Our Reference: RHC-24-235-TN (Please quote in all correspondence).

Transport Note: Land South of Charnwood Acres, Markfield Road, Ratby
(Application Number: 24/01126/FUL)

Further to our appointment by our client Mr R Pasch, I write to address the statutory consultation comments raised by Leicestershire County Council, dated 24th January (see **Appendix A**).

Rev	Description	Date
Client: Mr R Pasch		
Project: Land South Of Charnwood Acres Markfield Road Ratby		
Drawing Title: Access Resurfacing		
Drawing Number: RHC-24-235-01		
Revision: -	Sheet Size: A3	Scale: As Shown
Drawn & Checked By: AR	Date: 17/03/2025	Status: Information

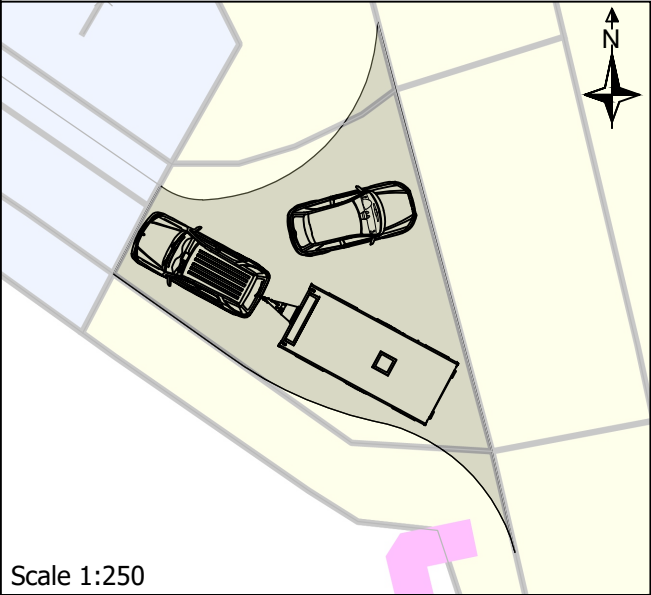
The Applicant has demonstrated proposed access arrangements on their submitted drawing titled "Road and Access Plan," drawing number 240239-01-06. However, they have not demonstrated that this will be surfaced with a hard bound material or that the largest vehicle likely to access the site could pass in the opposing direction to a car. Therefore, the LHA requests that the Applicant submits a scaled drawing detailing surfacing and access widths, in addition to a scaled vehicle tracking analysis drawing to demonstrate that a safe and suitable access can be provided for all users in accordance with the National Planning Policy Framework (2024).

The LHA requests that the Applicant demonstrate the surfacing arrangements of the access on a scaled drawing. The LHA requires 15 metres of hard bound material behind the carriageway edge to be provided at the access for the entire required width. The LHA further requests that the Applicant provide a vehicle tracking analysis drawing to demonstrate that the largest vehicle likely to access the site, can do so passing a car in the opposing direction.

To address this, the applicant proposes to widen the access, with the access resurfaced with hardbound material,

with the extents of the surfacing work shown on Drawing Number RHC-24-235-01, attached within **Appendix B**. It is noted that the resurfacing works are contained solely within the adopted highway, under the authority of Leicestershire County Council, and will not impact upon land which is managed by National Highways.

Rev	Description	Date
Client: Mr R Pasch		
Project: Land South Of Charnwood Acres Markfield Road Ratby		
Drawing Title: Swept Path Analysis (Refuse)		
Drawing Number: RHC-24-235-03		
Revision: -	Sheet Size: A3	Scale: 1:250
Drawn & Checked By: AR	Date: 17/03/2025	Status: Information

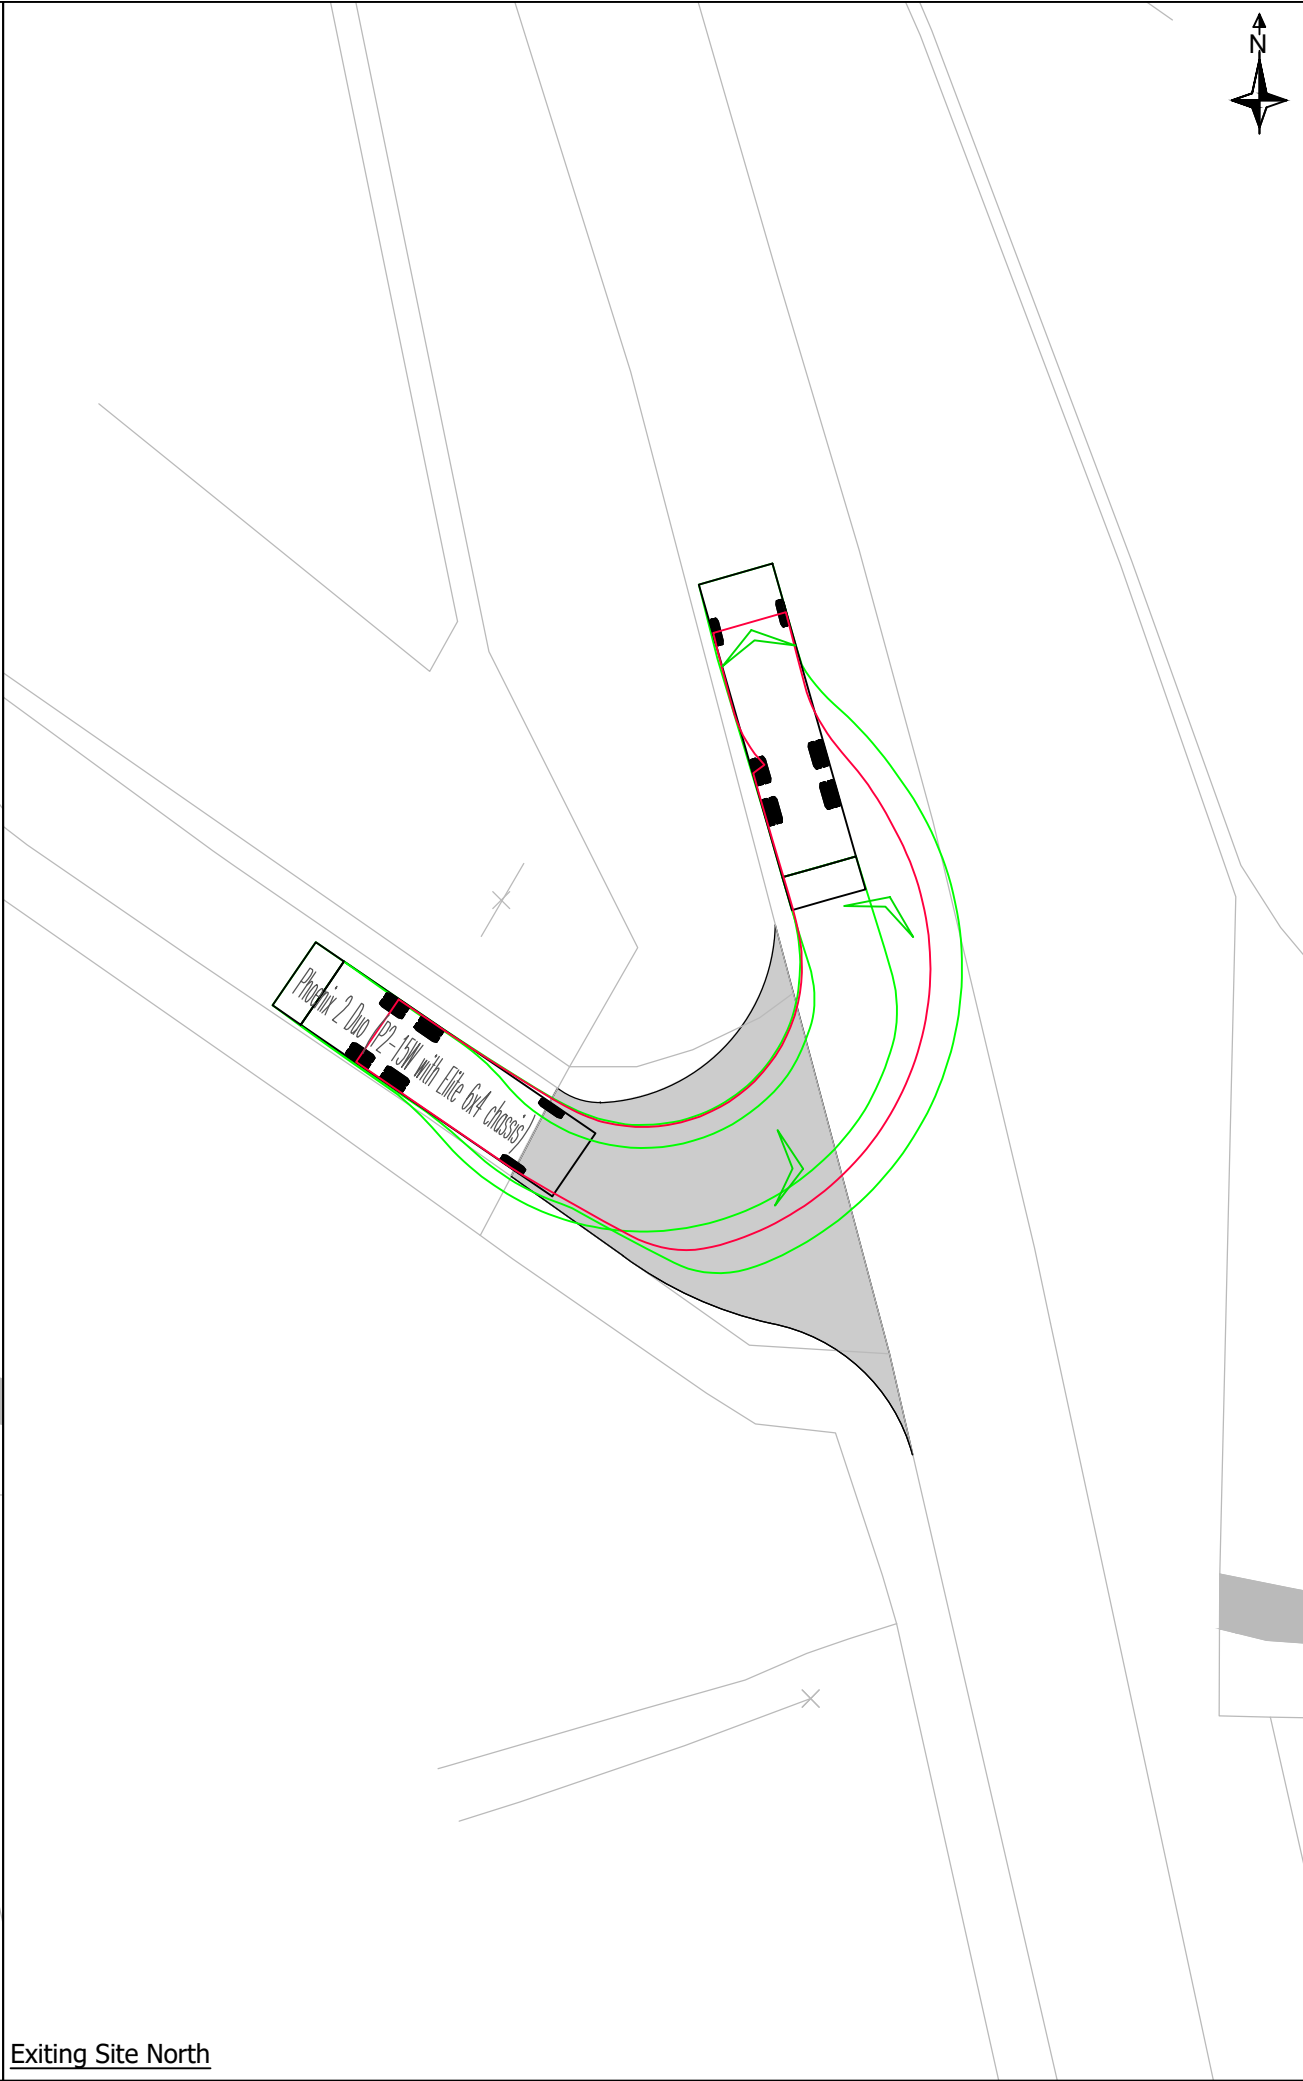
The Applicant's submitted drawing titled 'Road and Access Plan,' drawing number 240239-01-06 demonstrates that, at several points, the drive width of the proposed development falls below the required width of 3.7 metres. As the proposed development is situated over 45 metres from the highway, the private drive should be constructed in accordance with the 'General layout of a private development,' section of the LHDG, which states that for drives over 45 metres from the highway, emergency vehicles must be catered for by constructing the drive and any turning areas so they can accommodate commercial or service vehicles. The minimum width for access should be 3.7 metres (between kerbs) and fire vehicles should not have to reverse more than 20 metres. Development must be in line with British Standard BS9506, 2005 and Building Regulations Approved Document B, Fire Safety 2006. The LHA therefore requests that the Applicant submit a tracking analysis drawing demonstrating that a 11.2m refuse vehicle and fire appliance is able to access the proposed development.

Additionally, the LHA requests that the Applicant demonstrate the ability of a 11.2m refuse vehicle and fire appliance to access the site on a scaled tracking analysis drawing.

As shown on Drawings RHC-24-235-02 and RHC-24-235-03 in **Appendix C**, both vehicles can safely navigate the access without overrunning the highway verge, once resurfacing works are completed. Adequate space is also available for a 4x4 towing a horsebox to pass a car at the access.

As shown on Drawing RHC-24-235-02, the council's refuse vehicle accesses the site from the south and therefore, the swept paths shown on the drawing are reflective of the existing arrangements, which will remain unaffected as part of the proposals.

A suitable turning area exists along the drive, allowing the council's refuse vehicle to turn and exit in a forward gear. This turning area is located adjacent to the bin collection point serving existing premises. The client will ensure that the bins are positioned adjacent to the turning area on the morning of the collection day, managed by themselves.
